TYPE II DEVELOPMENT & ENVIRONMENTAL REVIEW, STAFF REPORT & DECISION

Project Name: HIGHWAY 99 POPEYES RESTAURANT

Case Number: PSR2009-00022, SEP2009-00042, BLA2009-00012 & EVR2009-00020

URBAN PRINCIPAL ARTERIAL (Pr-4cb)
4-LANE W/ CENTER TURN & BIKE LANES

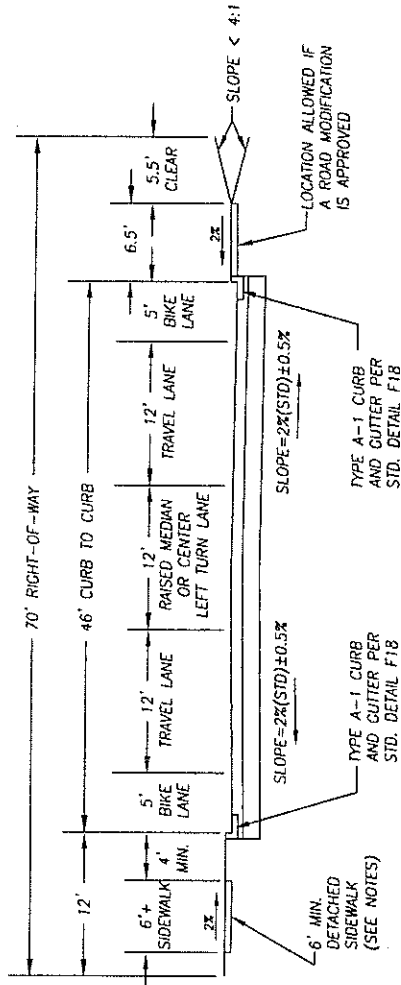
- a. NE 88th Street and NE Hwy 99 are classified as Urban Collector (C-cb2) and Principal Arterial (Pr-4cb), respectively. Both streets are currently constructed with attached 5-foot sidewalks. Both street details (Drawings 4 and 11) suggest that an attached sidewalk is allowed if a road modification is approved. Construction of a detached sidewalk would result in the applicant having to remove a relatively new, fully capable and equivalent sidewalk, which would be grossly disproportional to the impacts created. The alternate 5-foot attached sidewalk should be considered equal to the standard. In addition, a ruling in favor of an attached 5-foot sidewalk would be consistent with the site plan application to the south (PSR2008-00050) where a 5-foot attached sidewalk is being allowed to remain. Attached 5-foot sidewalk exists at both property lines, so allowing the consistent sidewalk to remain would also create a smooth transition for pedestrians moving past the site along both street frontages.

- The proposed modification to *Standard 40.350.030 (B)(3)* to allow a 5-foot attached sidewalk should be approved to maintain consistency throughout the region. The ruling would also be consistent with the site plan application directly to the south. The removal of the attached 5-foot sidewalk and replacement with a 6-foot sidewalk would be grossly disproportionate to the impact gained.
- The proposed alternate attached sidewalk design is equal to the standard.
- The bike lane along NE 88th Circle should not be required as NE 88th Street is not shown to have a bikeway at any point along its entirety. The applicant should not have to provide for bicycle circulation along this very short section that has recently been improved without bike lanes on either side.
- The 35-foot half-width right-of-way requirement should be reduced to 30 feet with the elimination of a 5-foot bike lane.

Staff supports the applicants proposal to not be required to reconstruct the frontages of NE Highway 99 and NE 88th Circle per CCC 40.550.010(A)(1)(d). However, the applicant shall be responsible for dedicating 35 feet of half-width right-of-way along the frontage of NE 88th Circle. **(See Condition A-2b)**
